RE: Review of File # Z25-371PPLT (Initial Agency Review)

This letter is to inform you that the application materials for the above-mentioned Preliminary Plat were found to be technically incomplete, based on a review required under Spokane Municipal Code (SMC) 17G.061.120, Determination of a Complete Application. The following comments were received from various departments and agencies.

From sewer drawing.

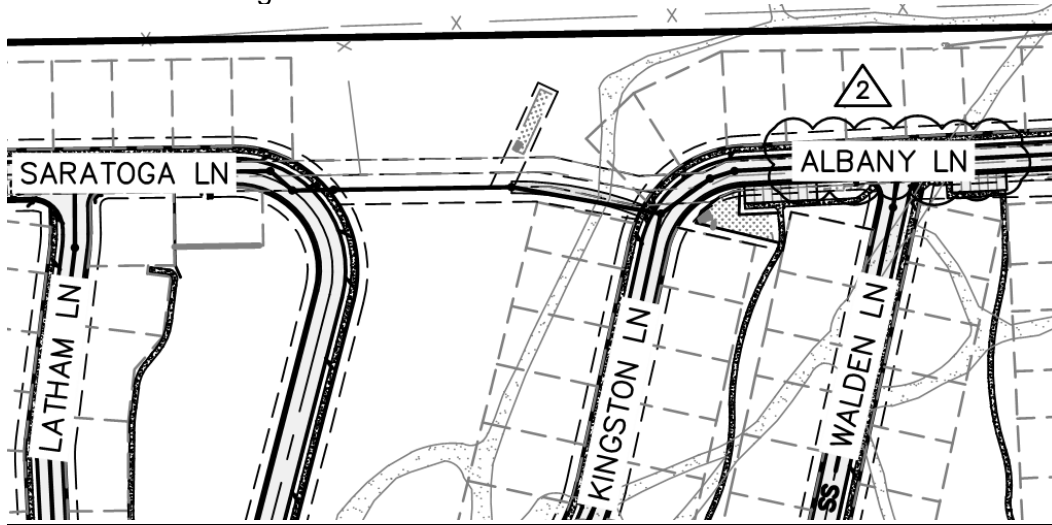
- A. It appears they have left off the utility easement for both water and sewer in parallel from Saratoga to Albany. Easement will need to be 30' wide, not 16' wide, and should be within a utility tract for boundary definition. (M. Owen Note: A new separate easement will need to be recorded and documented on the plat map prior to final plat approval per M. Owen Conversations with Eldon Brown.)

From sewer drawing.

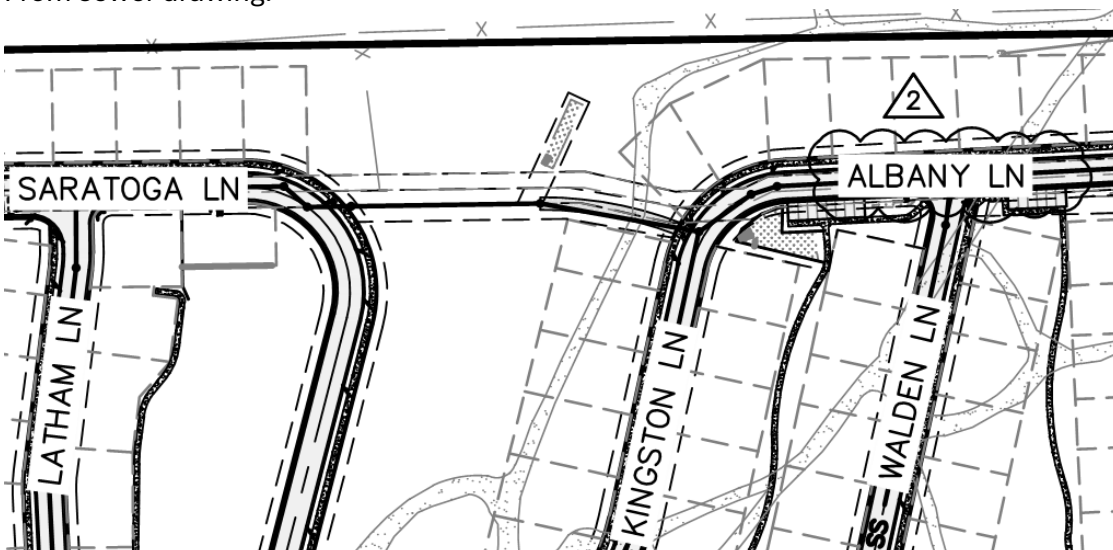
It appears they have left off the utility easement for both water and sewer in parallel from Saratoga to Albany. Easement will need to be 30' wide, not 16' wide, and should be within a utility tract for boundary definition.
